**APPLICATION FOR PERMISSION
UNDER SECTION 16 OF
THE TOWN PLANNING ORDINANCE
(CAP. 131)**

Planning Statement to support the renewal of the Application No. A/YL-NTM/432

**Transitional Housing at Various Lots in D.D. 104 & Adjoining Government Land in
Ngau Tam Mei South, Yuen Long
Noise Traffic Forecast for Environmental Assessment Study: Response to Comments**

From: [REDACTED]
Sent: 2024-03-21 星期四 12:00:07
To: tpbpd/PLAND <tpbpd@pland.gov.hk>
Cc: Karen Kei Yee CHAN/PLAND <kkychan2@pland.gov.hk>;
[REDACTED]
Subject: Ngau Tam Mei South - Planning Application No. A/YL-NTM/470
Renewal Application
Attachment: 20240321 Renewal Application.zip

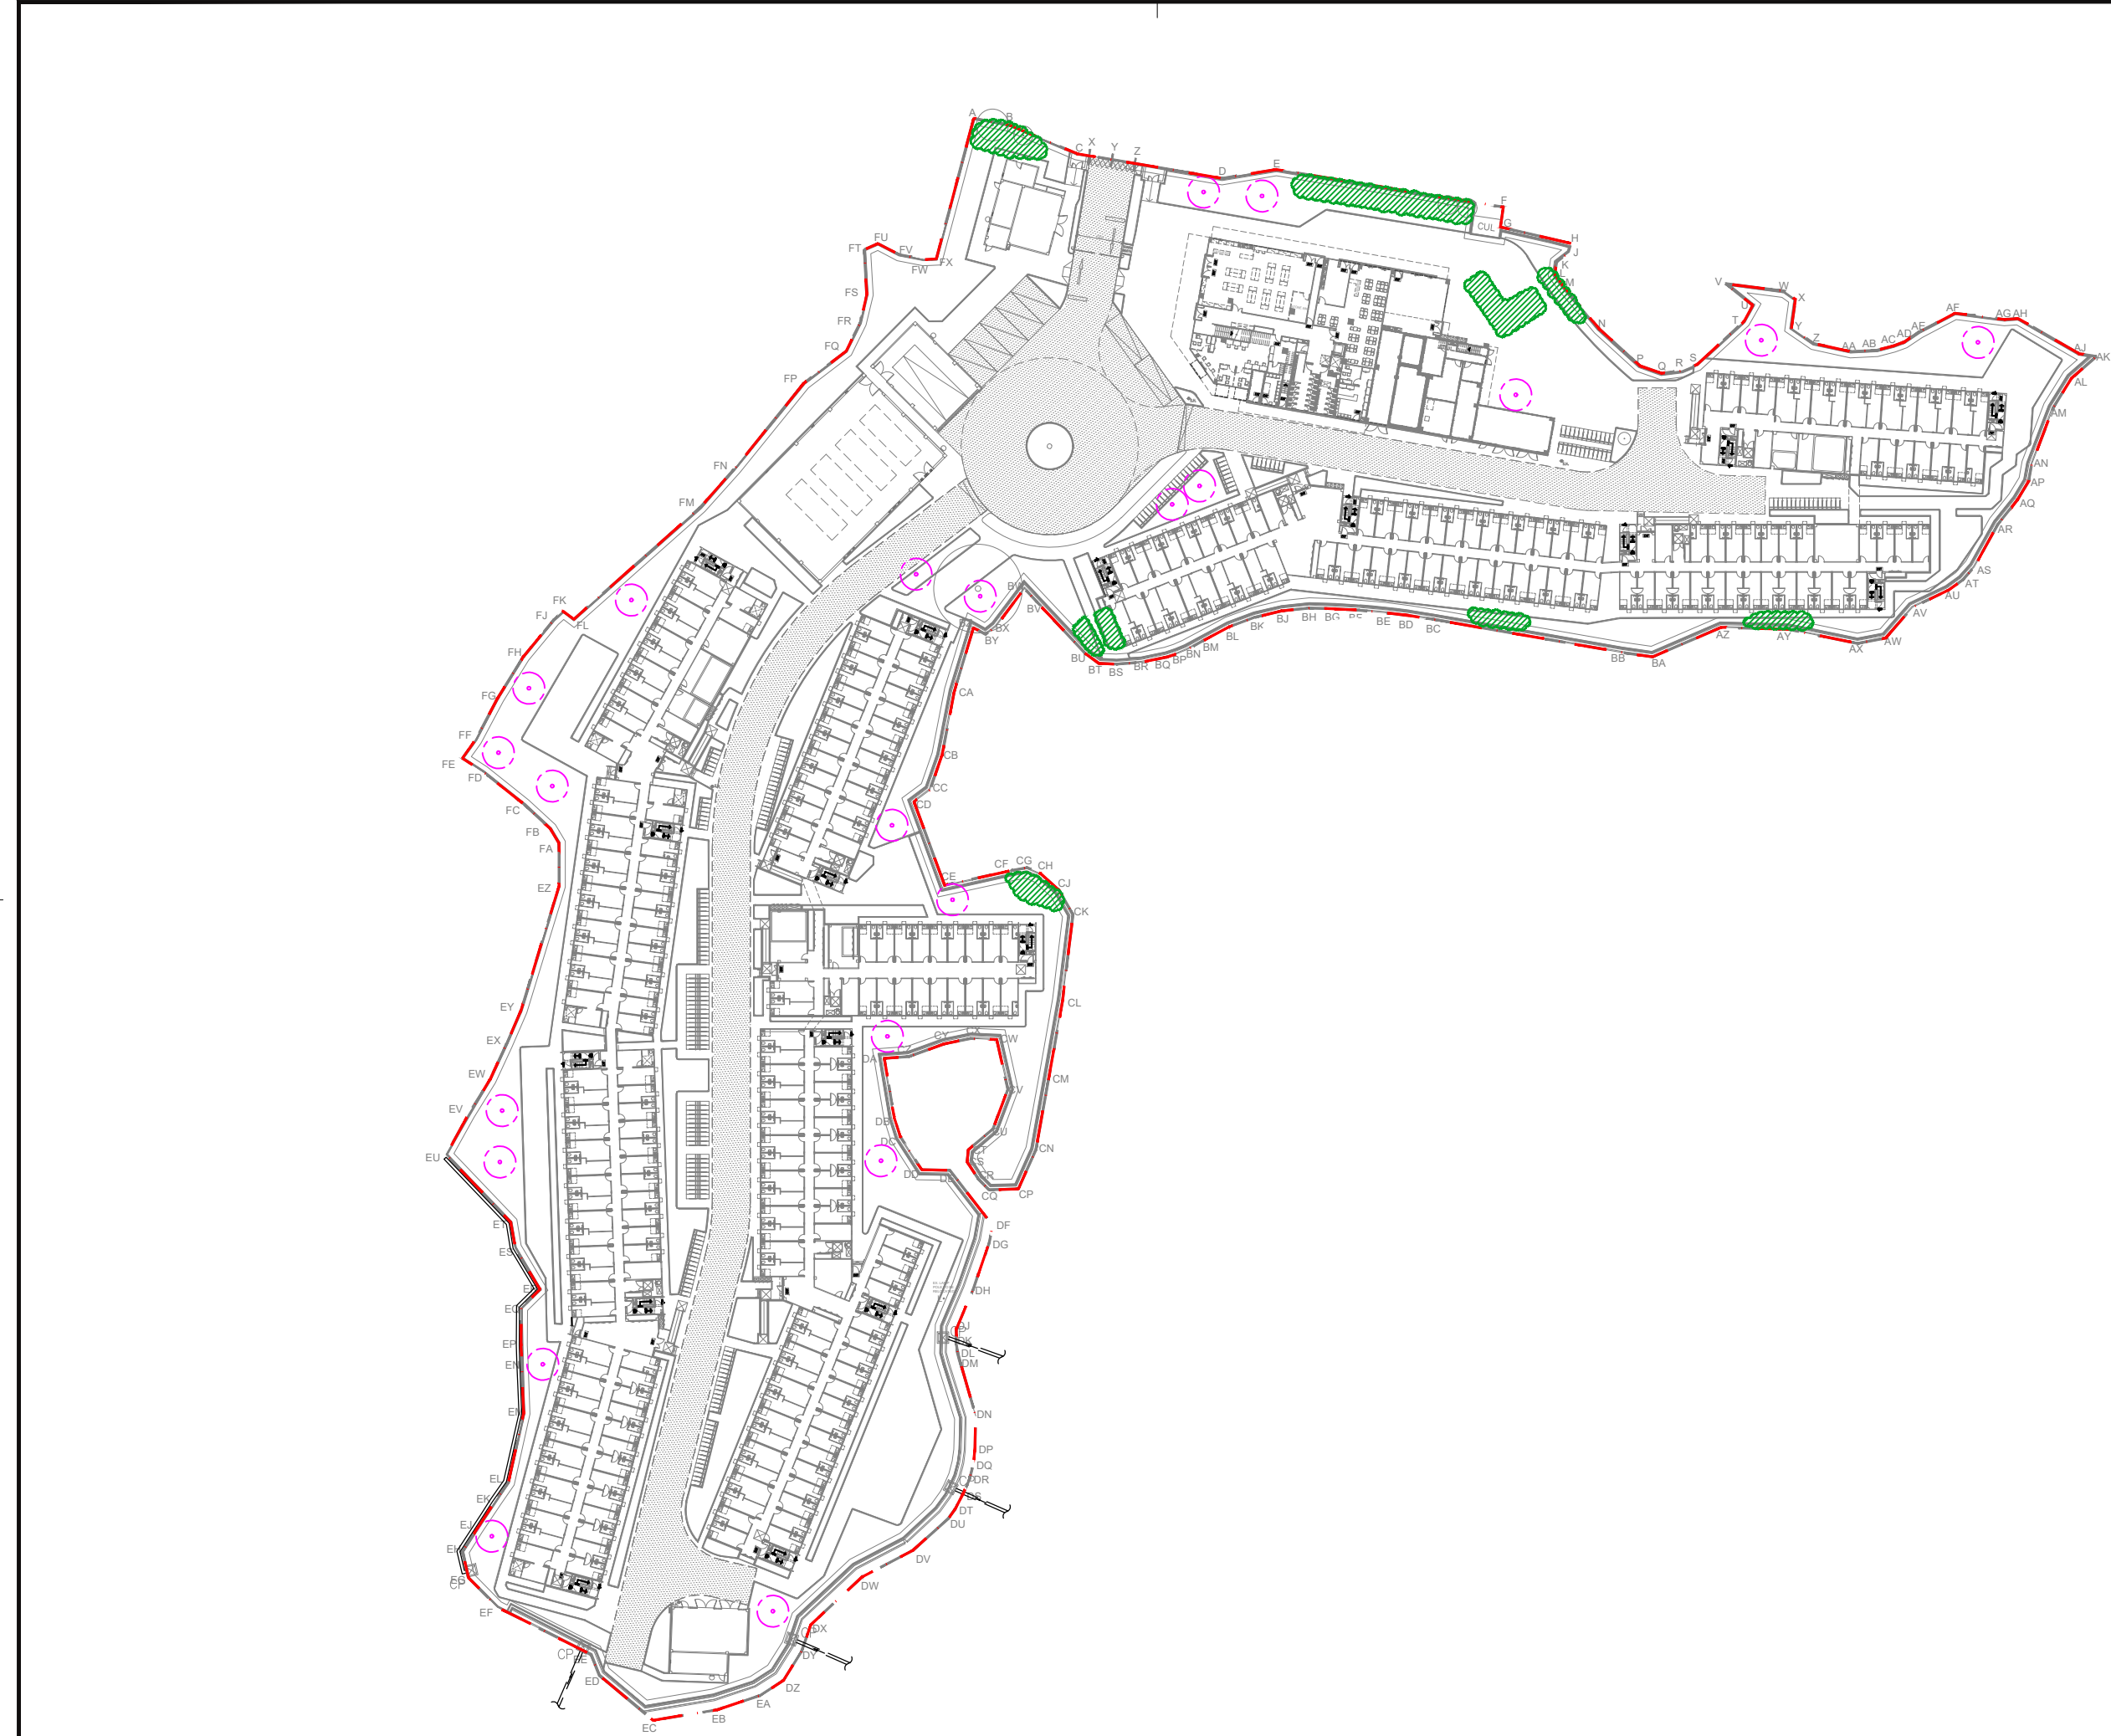
Comment (v) Spot levels should be indicated on the LLP.

Reply *Noted. Please refer to revised LLP.*
